CITY OF MOUNT VERNON
DESIGN REVIEW BOARD MEETING
CONTINUATION FROM APRIL 6, 2021
April 26, 2021

DESCRIPTION	PUBLIC HEARING?		ACTION REQUIRED	STAFF CONTACT
1.	Approval of a New Façade, Parking and Landscaping for the Bank of America Building Located at 320 E Kincaid St	<input checked="" type="checkbox"/> Yes	<input type="checkbox"/> No	Motion	Rebecca Lowell

STAFF RECOMMENDATION FOR THE DESIGN REVIEW BOARD DOWNTOWN DESIGN REVIEW

PROJECT ADDRESS:	320 West Kincaid Street	PERMIT NUMBER:	PLAN21-0069
APPLICANT:	Magellan Architects	PROJECT PARCEL NUMBER(S):	P54136 and P54137
PROJECT DESCRIPTION:	The City's Design Review Board will be reviewing and approving the new façade, parking and landscaping site subject to design review per Mount Vernon Municipal Code Chapter 17.70 for the approximate 6,705 square foot Bank of America building located on the below-described approximate .68-acre site.		
APPLICABLE MVMC:	MVMC CHAPTERS 17.70, 17.45 AND 14.05		
EXHIBITS:	EXHIBIT A: Master Land Use Application from the Applicant EXHIBIT B: Proposed Plans and Information from the Applicant EXHIBIT C: Public Notice Information

01 NORTH ELEVATION
1/4" = 1'-0"

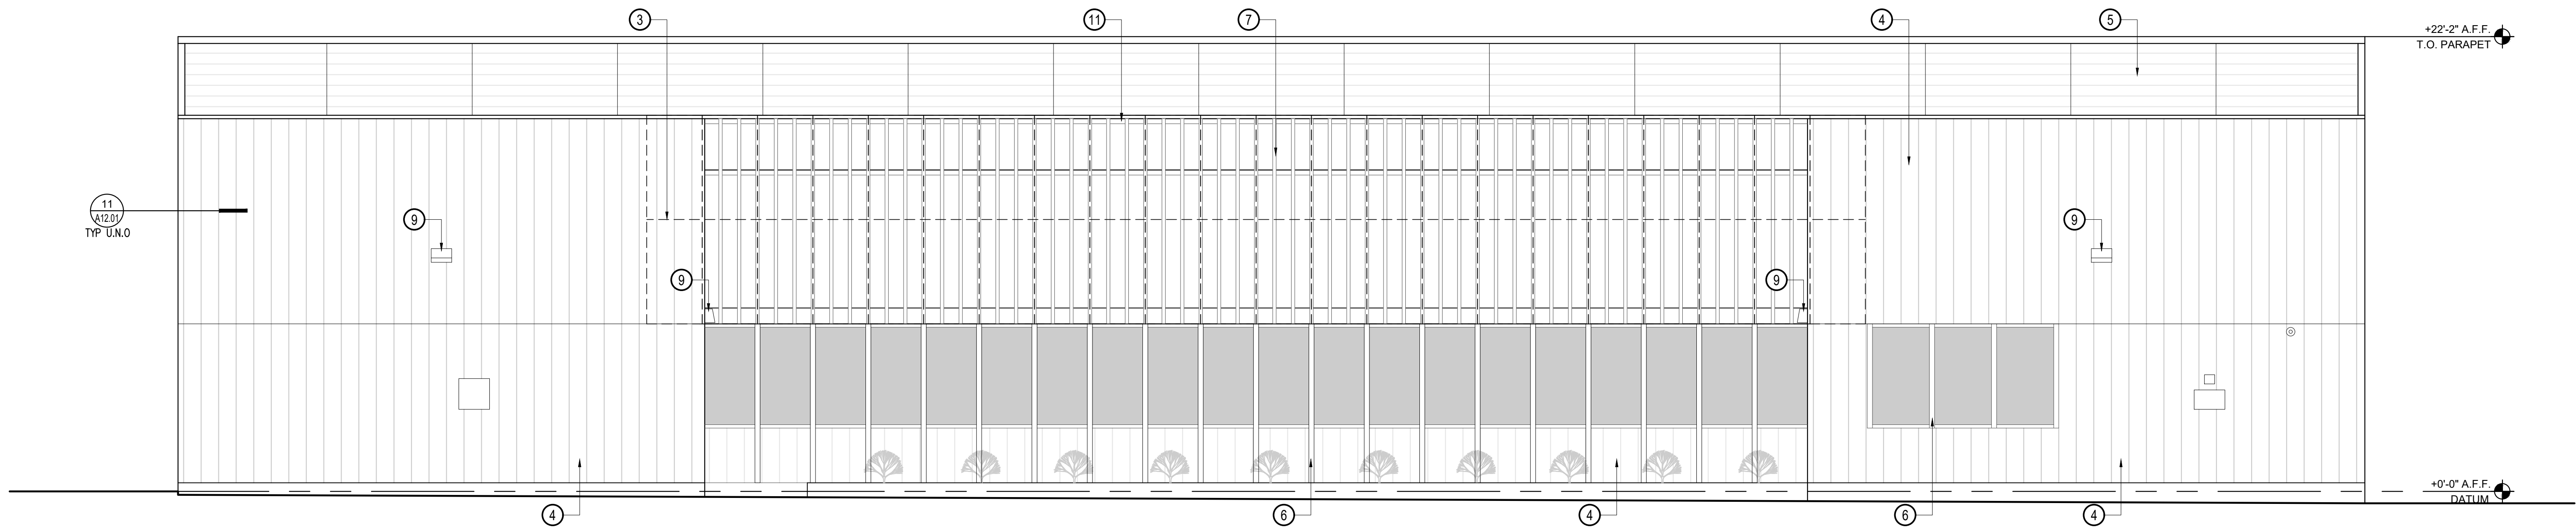
The north façade facing W Kincaid Street between 2.5 and 12 feet above abutting grade consists of approximately 614 square feet within which approximately 195.5 square feet of transparent windows/doors are shown. This is 31.8% of this façade.

The weather protection abutting W Kincaid Street is 14.7 feet in width; which means it comprises 22% of the 66.25 linear foot frontage.

The windows on the north and south side of the structure allow visibility into the structure. However, the Board will need to decide if the windows on the west side of the building will need to allow visibility into the structure as these windows currently do not.

Most of the windows have a vertical proportion of approximately 2:1 (height to width). However, the windows on the north and south side of the structure above the doors do not meet this proportion (the south windows are approximately 2.25 wide by 2.6 tall and the north windows are approximately 2.5 wide by 3.6 tall).

01 SOUTH ELEVATION
1/4" = 1'-0"

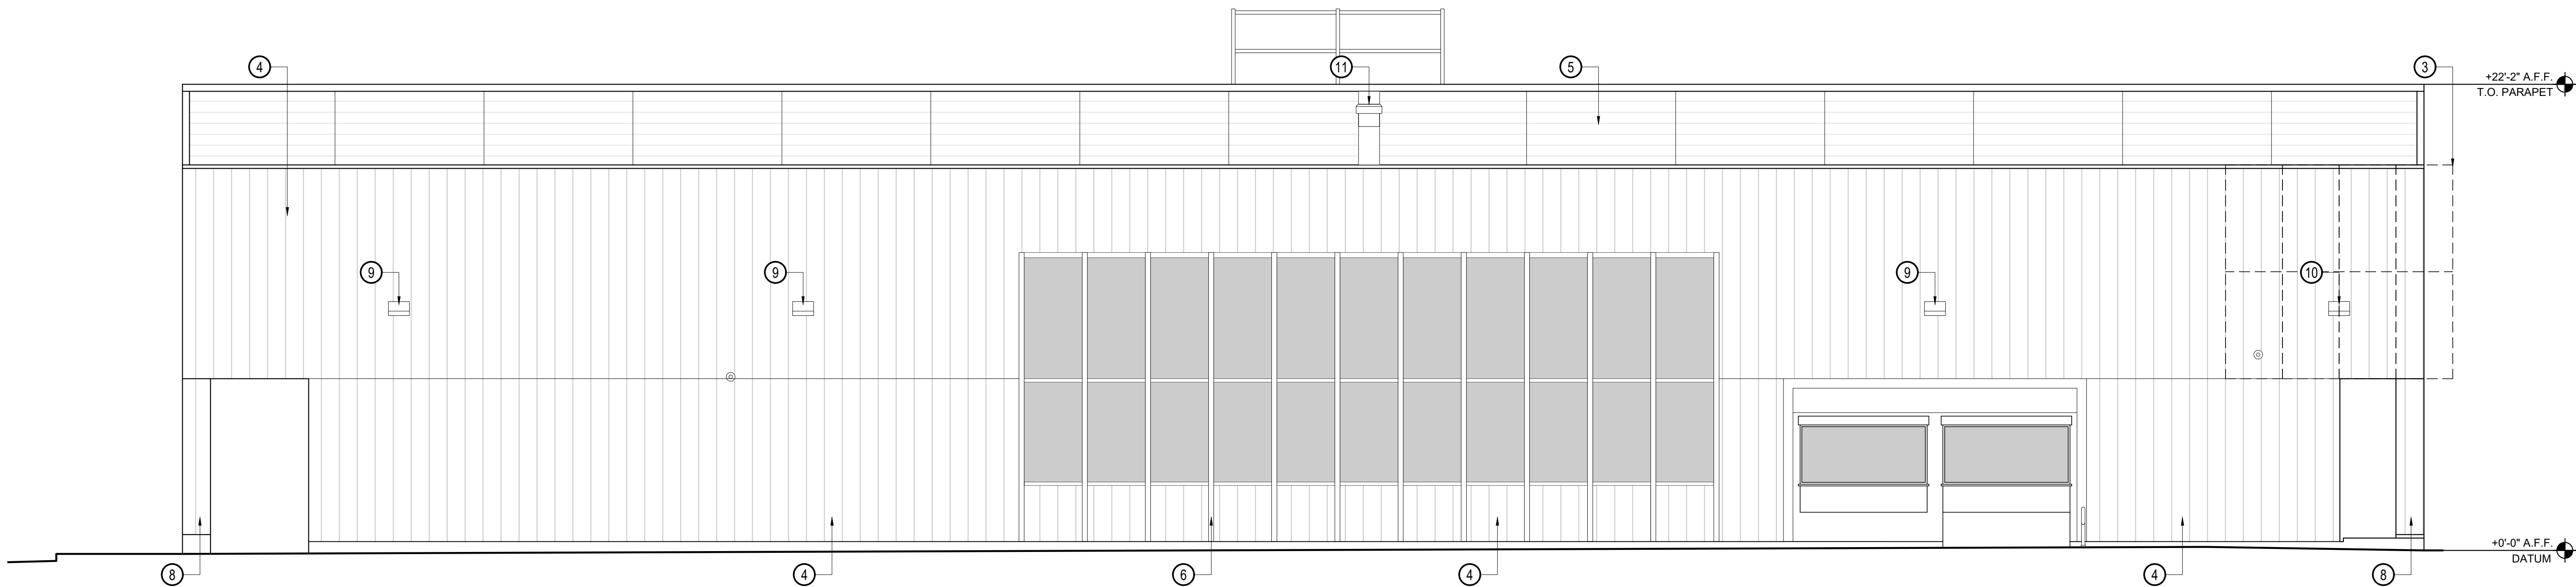
The east and west elevations all have flat, blank walls with surface areas of 400 s.f. or more.
